From: KarenD Hadden <karendhadden@gmail.com>
Sent: Monday, July 30, 2018 11:20 PM
To: HOLTEC-CISEIS@nrc.gov; Holtec-CISFEIS Resource
Subject: [External_Sender] Public Citizen and SEED Coalition Comments on HOLTEC-CIS Application
Attachments: Holtec Comments Final 7-30-18.docx

Federal Register Notice: 83FR13802
Comment Number: 3480

**Holtec's Radioactive Roulette:
Why High Level Radioactive Waste Should Not Be Stored in New Mexico**

**Ref: USNRC Docket No. 72-1051
THE PROPOSED HI-STORE CIS FACILITY
July 30, 2018**

Figure 6B-1 New Mexico State Rail System in 2014

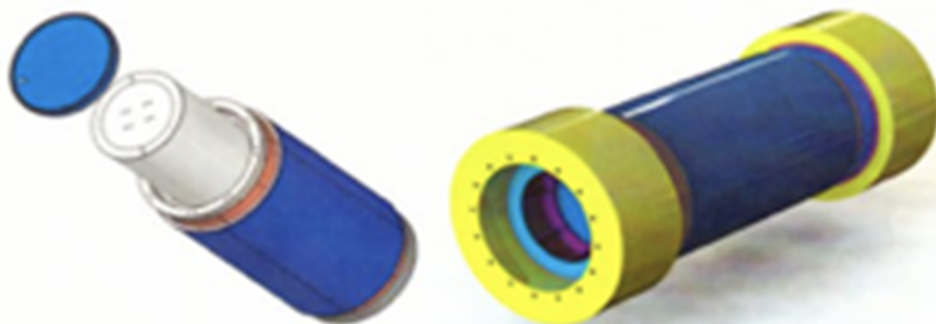
The rail lines that would carry radioactive waste would run right along the edge and potentially over a mined out section of the Carlsbad sinkhole. Overweight radioactive waste trains alongside a sinkhole create a recipe for disaster. John Heaton, Holtec's spokesman, says that this concern is unfounded because the rail lines run to the north of Carlsbad, but Holtec's

application (page 157) and the above New Mexico State Rail map shows that line running along Highway 285 and then east along 62 to the Holtec site.

HI-STAR 190 Transport Cask

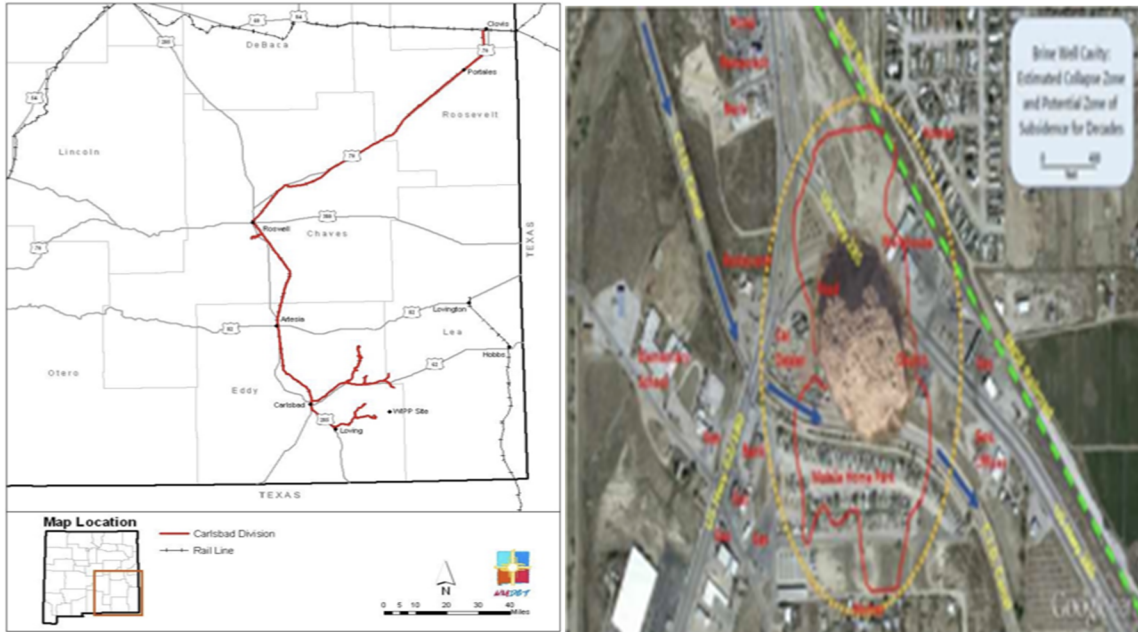
Each loaded car would weigh 185 to 207 or more tons, far more than the 143 tons than the tracks are designed to carry per rail car according to testimony by railroad engineers at recent legislative hearings.

The Federal Railroad Commission has said "A more robust track structure is required to handle these heavier cars. Many short lines did not have track and bridges capable of handling the heavier loads." Summary of needs of class II and III Railroads Federal Railroad Administration 2014 pg 5 ⁴

When asked if the rail lines in New Mexico could safely handle cars of this weight- both Scott Palmer and Don Gallegos of the Brotherhood of Locomotive Engineers and Trainmen said they were "not good enough" at the July 19th Interim Committee meeting in Hobbs, NM.
